CITY OF ALBUQUERQUE

**RE: I-25 west Frontage Rd between Venice & Pasadena
Conceptual Grading and Drainage Report
Plan Date: 8/3/17
Hydrology File: B18D022**

Based upon the information provided in your submittal received 8/4/17, the above referenced submittal cannot be approved for Site Plan for Building Permit until the following comments are addressed:

SHEET NUMBER:
C-1

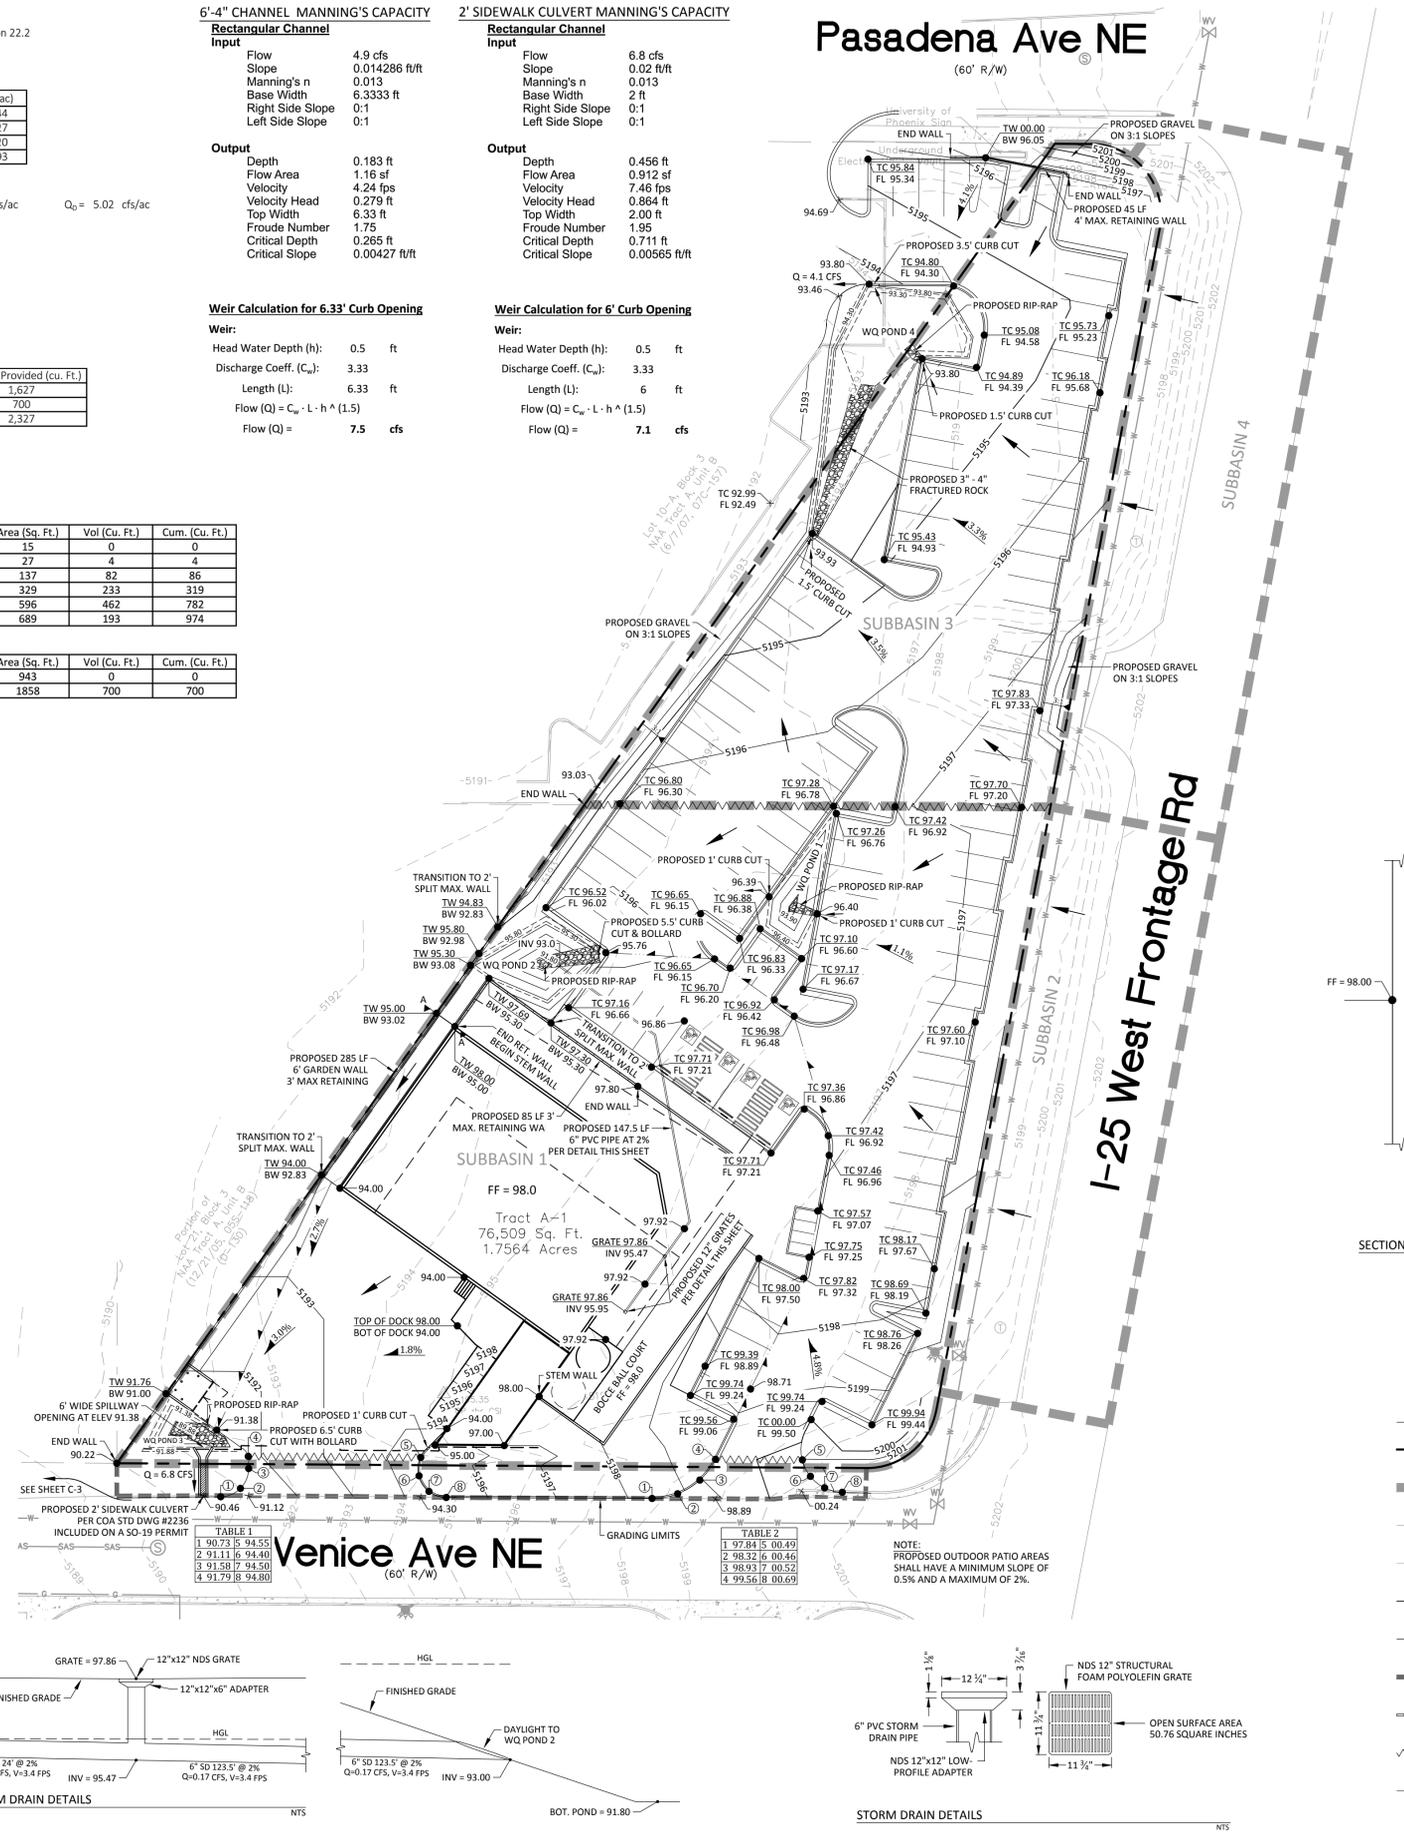
3. The downstream storm drain inlets will need to be built in accordance with the ultimate design: 1x single A and 1x double C.
4. Per Ch. 22, Section C.e (2) of the DPM, channels draining to inlets must be armored. Provide concrete transition slabs and curb for the inlets and standard curb and gutter between the two inlets. Provide riprap protection around the inlets and immediately upstream.

5. Freeboard must be provided for the channel.
6. In section A-A, show the adjacent lot existing grade and the footer (if any); include a note that the wall, footer, and grading will not encroach upon the adjacent lot.

7. For conceptual grading and drainage plans, label as 'not for construction.'

SHEET NUMBER:
C-2

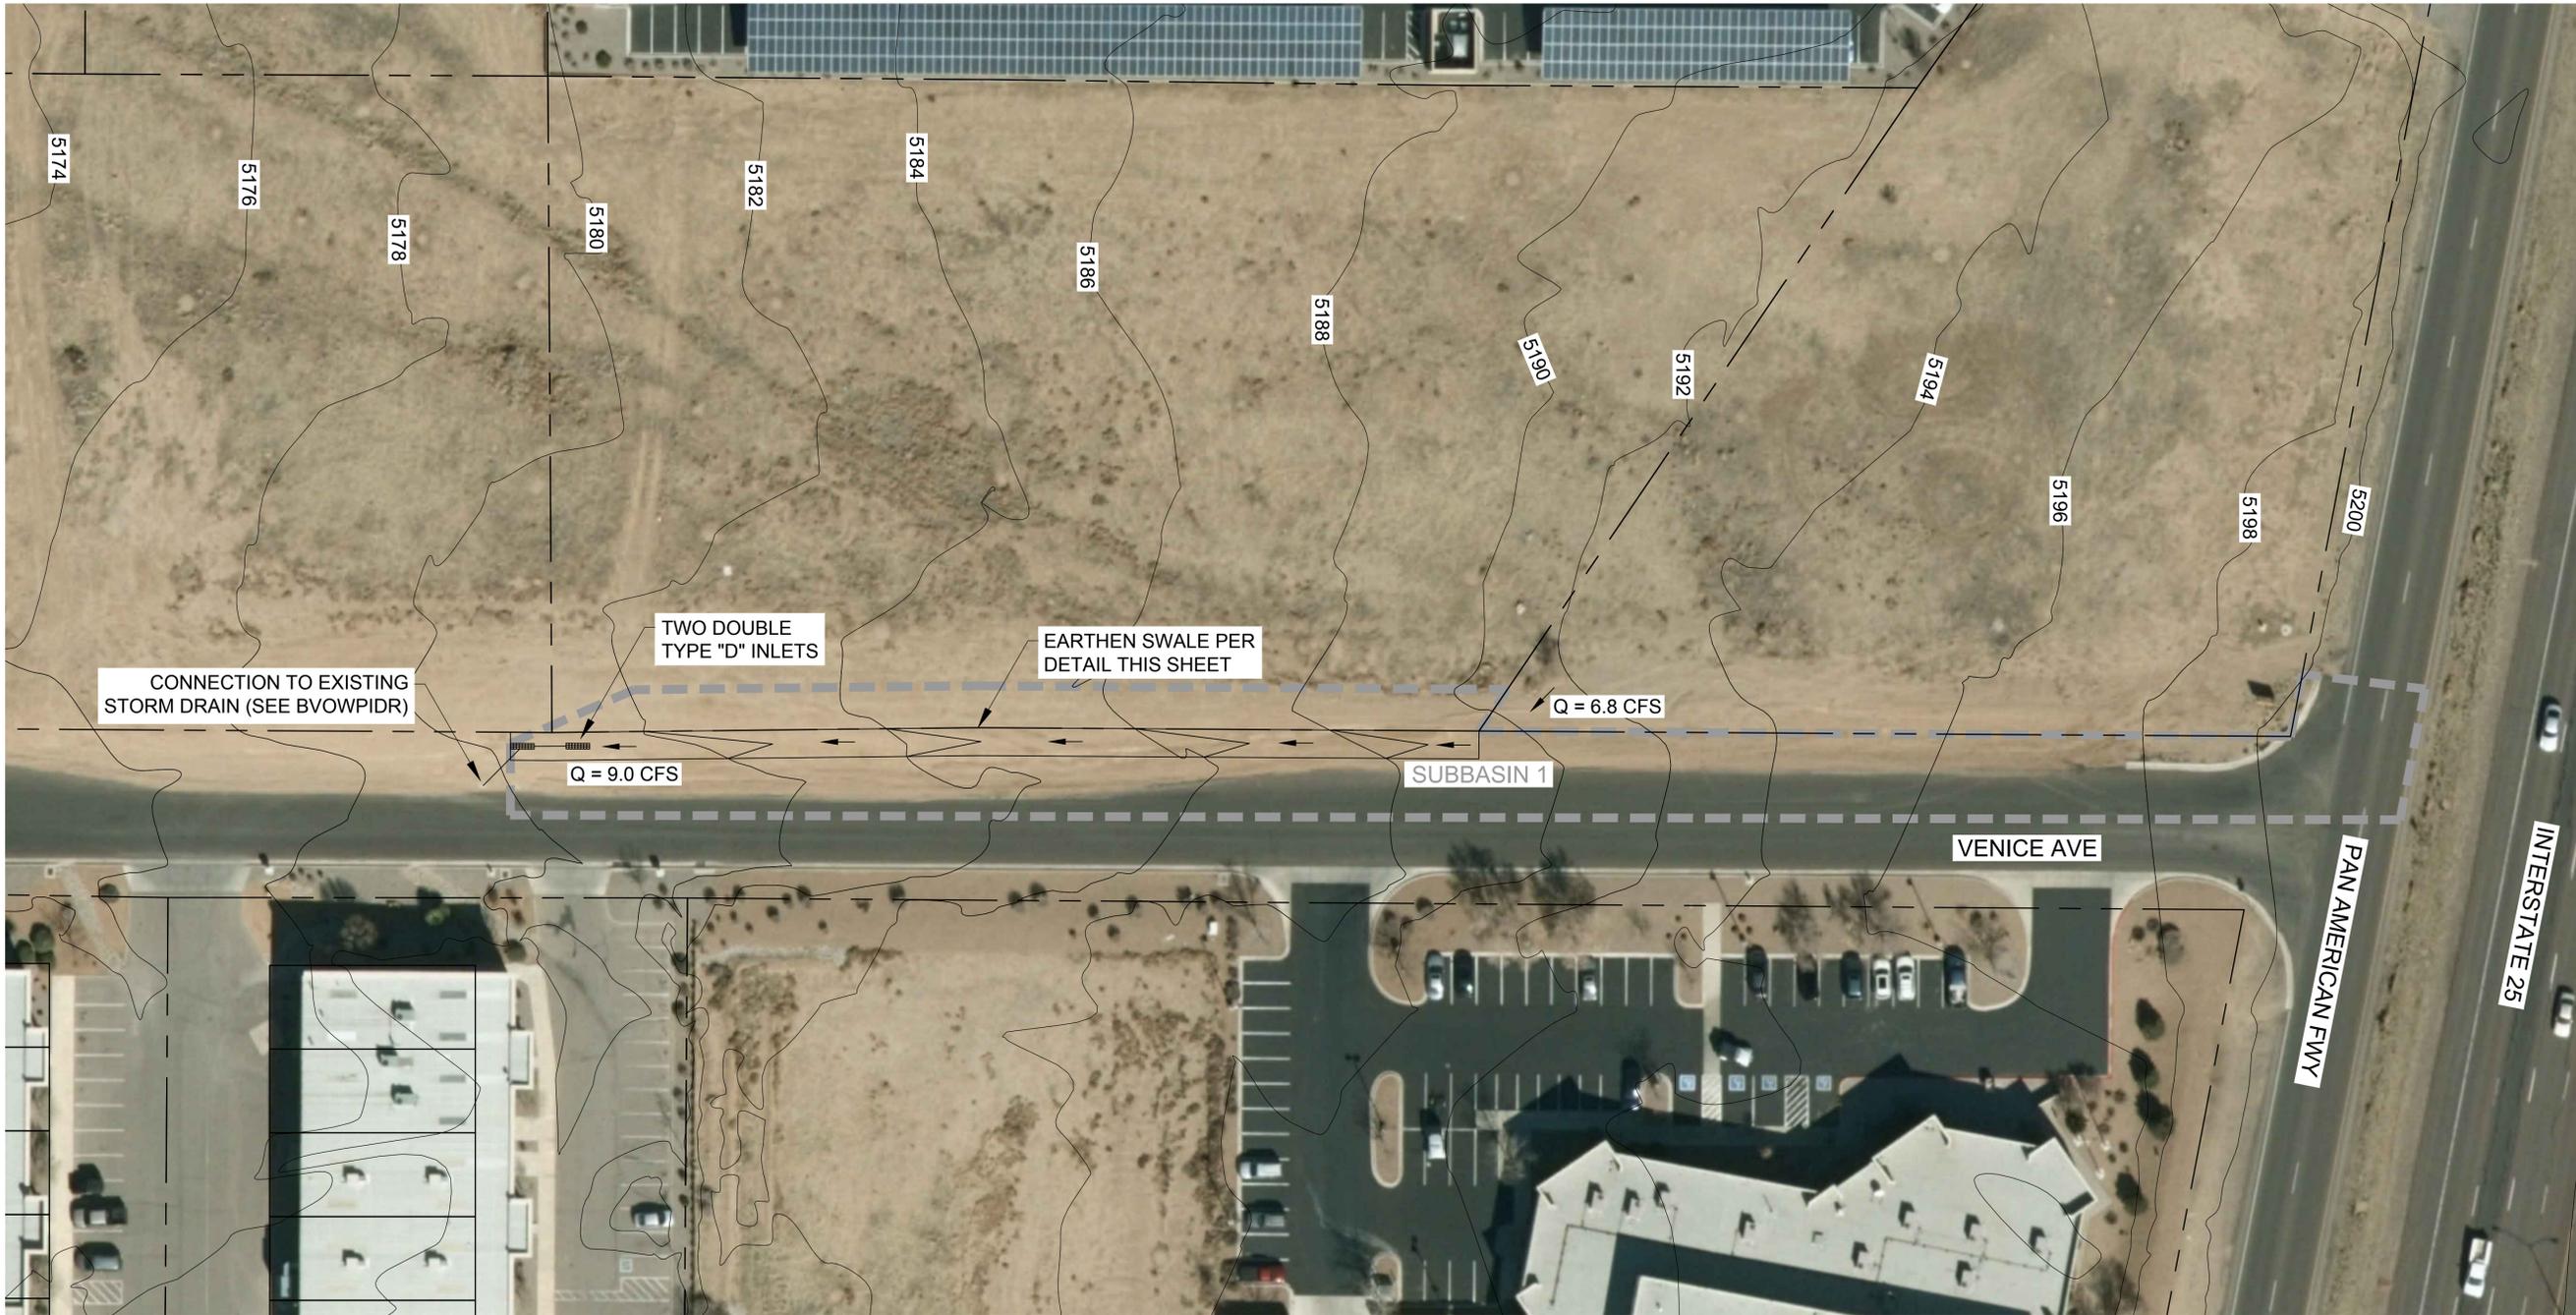
1. A cross lot drainage easement will be required with University of Phoenix in order to discharge onto their lot.
2. An agreement and covenant with the owner of Lot A1 to maintain the temporary swale in the Venice ROW will be required.
